Volume 4

Environmental Assessment of the Township of North Dundas Waste Management Plan

Volume 4 – Record of Consultation

Comments Received on the Draft EA

Figure 1 SPIA map showing location of Boyne Road Landfill. Proposed project area (shown in red polygon) is located in WHPA D with vulnerability score 4 (yellow shade), IPZ 3 with vulnerability score 7 (light blue shade), HVA scoring 6 (pink hatching) and a SGRA (green shade).

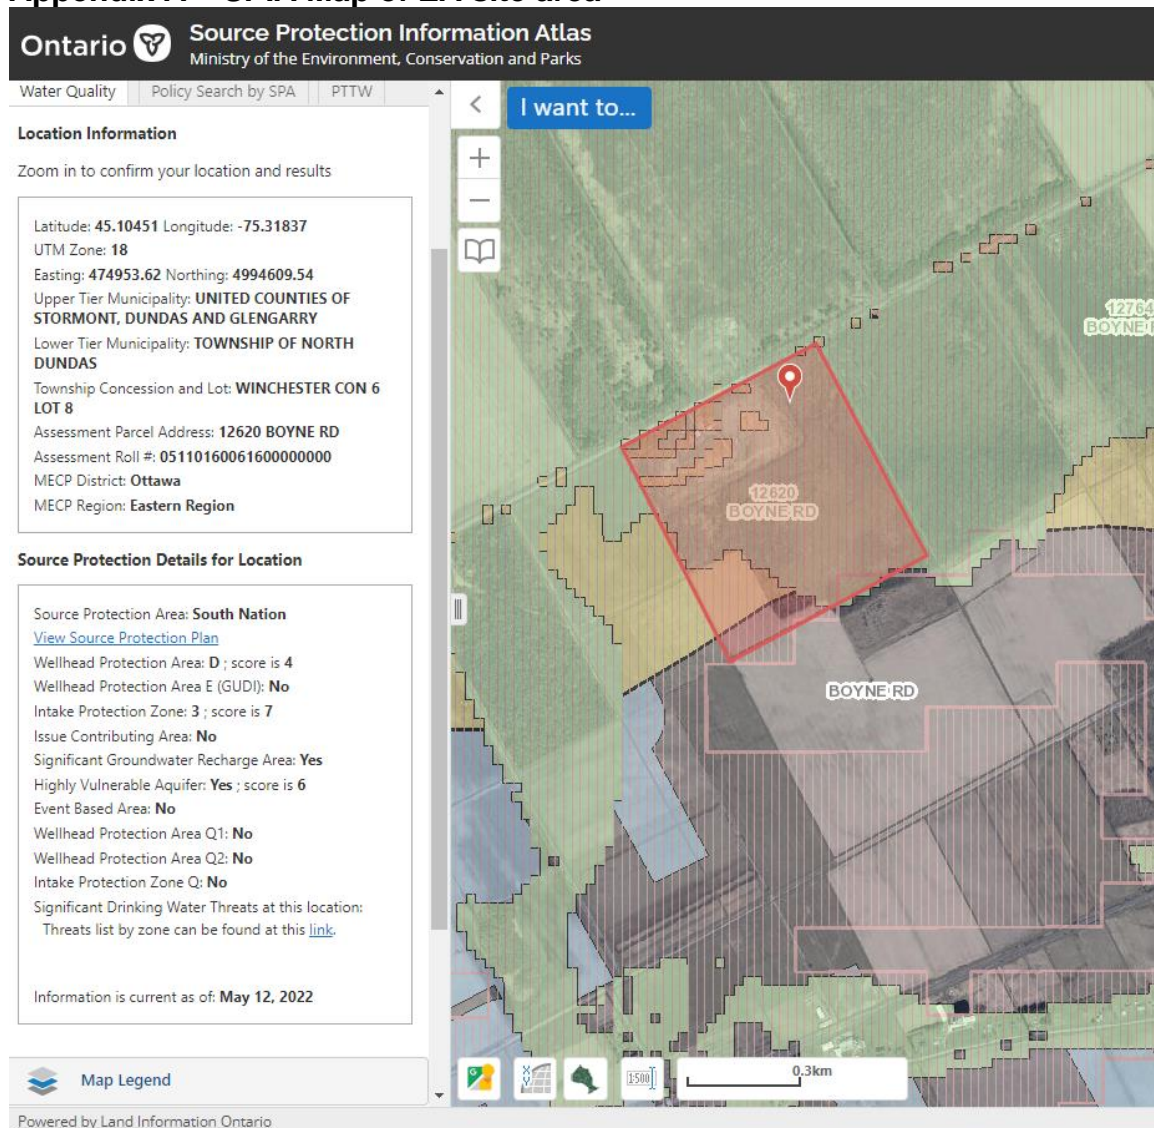
Boyne Road Landfill is located at Lot 8, Concession VI in the former Township of Winchester. As shown in Figure 1 in Appendix A, the study area falls within Wellhead Protection Area (WHPA) D with vulnerability score 4, Intake Protection Zone (IPZ) 3 with vulnerability score 7, Highly Vulnerable Aquifer (HVA) scoring 6 and a Significant Groundwater Recharge Area (SGRA).
